**AMENDMENT - INVITATION TO TENDER**

<b>Title-Sujet:</b> Construction – Wabasca-Desmarais Detachment	
<b>Solicitation No. - No. de l'invitation</b> 201804138	<b>Date</b> Feb. 1st, 2018
<b>Client Reference No. - No. De Référence du Client</b> 201804138	<b>Amend No.- No. du modif.</b> 007
<b>GETS Reference No. - No. de Référence de SEAG</b> 201804138	
<b>Solicitation Closes –L'invitation prend fin</b>  <b>at - à</b> 16 :00 ET <b>on - le</b> Feb. 6th, 2018	
<b>F.O.B. - F.A.B.</b> Destination	
<b>Address Enquiries to: - Adresser toutes questions à:</b>  <a href="mailto:jordan.mckenna@rcmp-grc.gc.ca">jordan.mckenna@rcmp-grc.gc.ca</a>	
<b>Telephone No. - No de telephone</b> 613.843.5518	<b>Fax No. - N° de FAX:</b>
<b>Destination of Goods, Services, and Construction: Destinations des biens, services et construction:</b>	
<b>Delivery Required - Livraison exigée:</b>	<b>Delivery Offered - Livraison proposée</b>
<b>Name and title of person authorized to sign on behalf of Vendor/Firm Nom et titre de la personne autorisée à signer au nom du fournisseur/de l'entrepreneur</b>

**ADDENDUM No. 05**

**GOVERNMENT OF CANADA  
WABASCA-DESMARAIS GOVERNMENT BUILDING**

**E2.1**

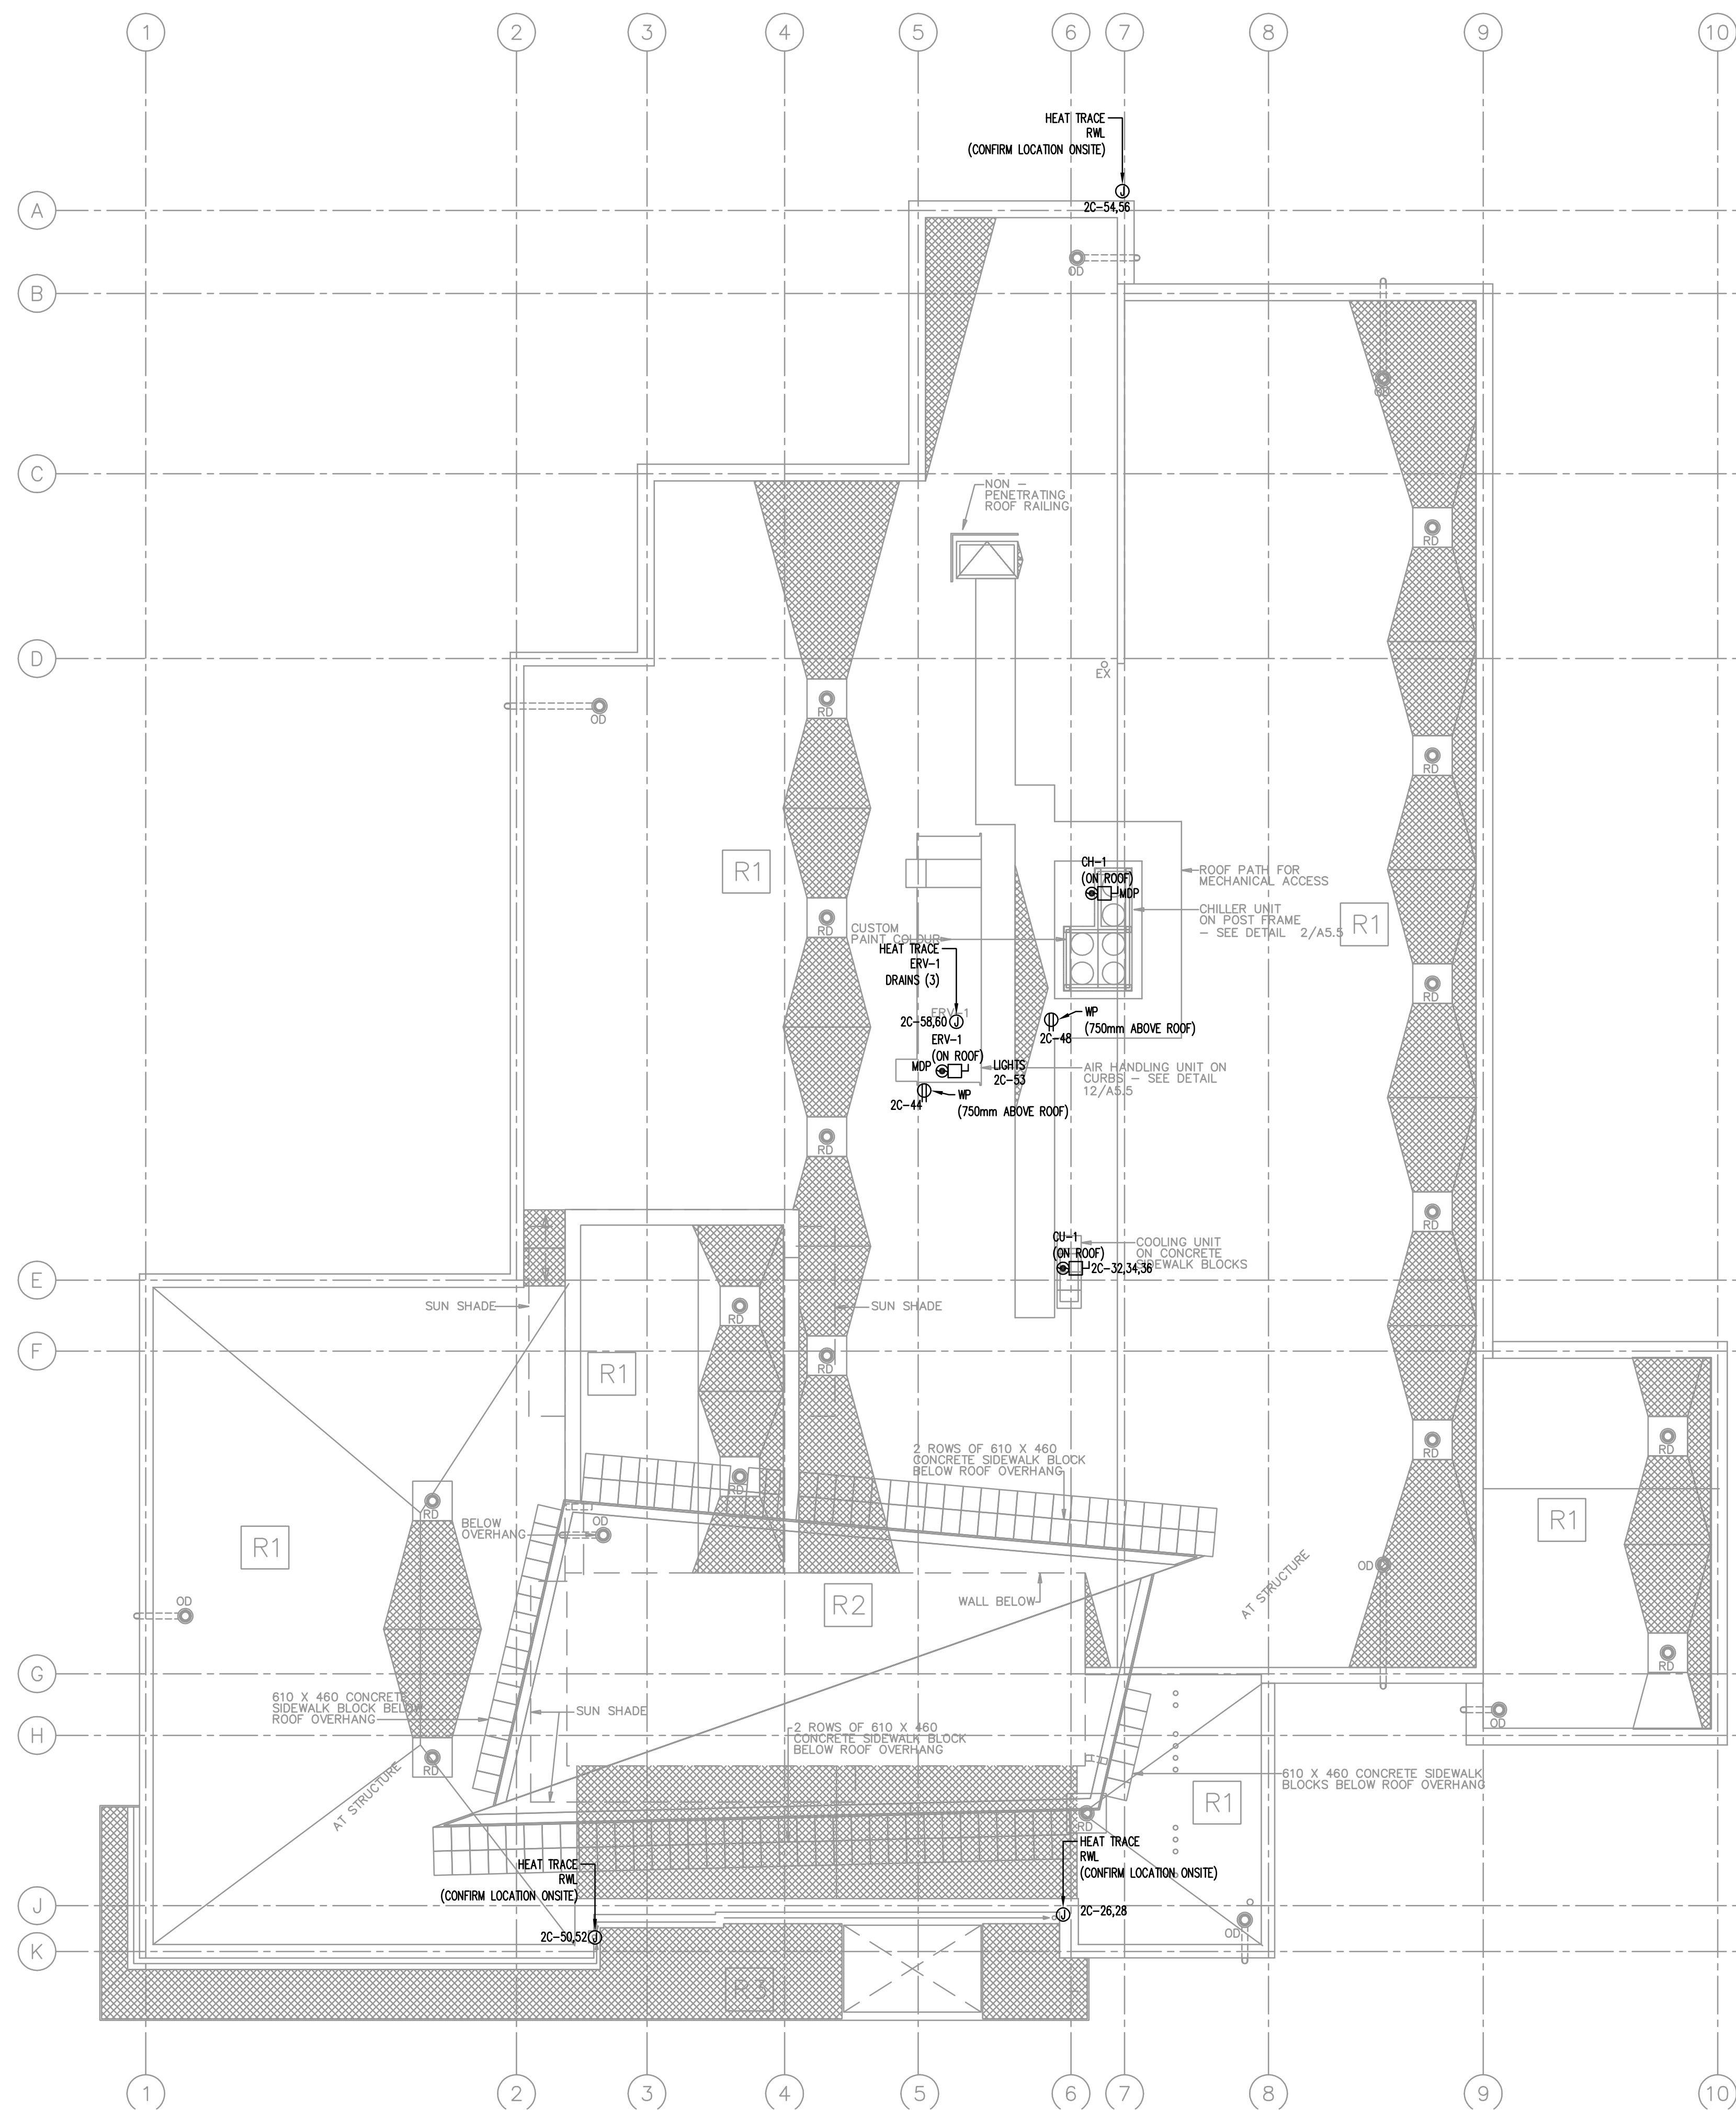
**REVISE:** Drawing has been re-issue with this addendum to address coordination with architectural plans.
